CITY OF TACOMA
Public Works Engineering

ADDENDUM NO. 03

Request for Bids Specification No. PW20-0015F
Revitalizing Tacoma's Brewery District

TRAFFIC SIGNAL
FAWCETT AVE
S 19TH ST AT FAWCETT AVE

SHEET SG-01 OF SG-09

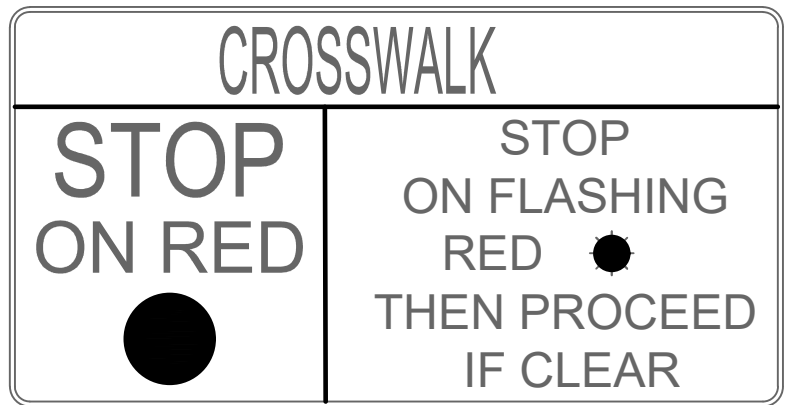
- 2. On plan sheet SG-01, construction notes (2) & (4) call for 35' mast arms on the signal poles, yet plan sheet SG-04, the signal detail chart calls for 30' mast arms. Which is correct?**

- 3. Plan sheet SG-01, construction notes (2) & (4) call for new LED roadway fixtures, yet no wattage is specified?**

The signal detail chart specifying 30 feet mast arms is correct. Please see replaced plan sheet SG-01 included in Addendum 03.

Luminaires shall be 400WEQ. Please see replaced plan sheet SG-01 included in Addendum 03.
